***Re: Proposed Development 1 Chesterford Gardens, London NW3 7DD,
Application 2020/1502/P***

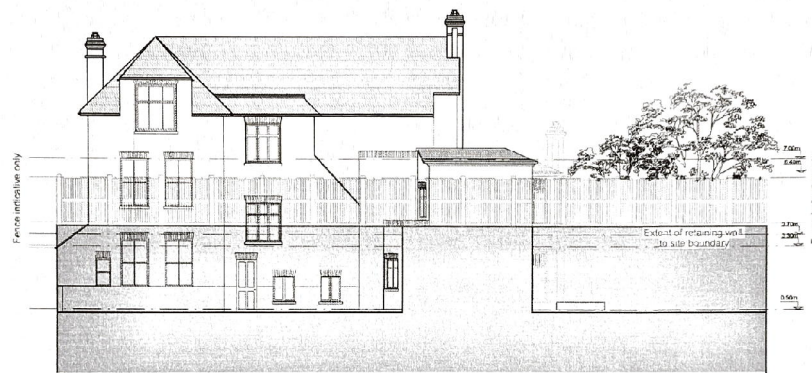
The first picture shows the current outlook from my garden toward the applicant's property and the uninhibited view towards Chesterford Gardens. The current garage building, which the applicant intends to replace with the new side/rear extension building, is barely visible over my garden fence.

In the next picture, I have super-imposed a red-block to highlight the approximate size and height of the proposed building based on the drawings provided by the applicant.

The illustration probably does not even depict the negative impact properly as the intended development would have a large shear wall sitting right at the property line
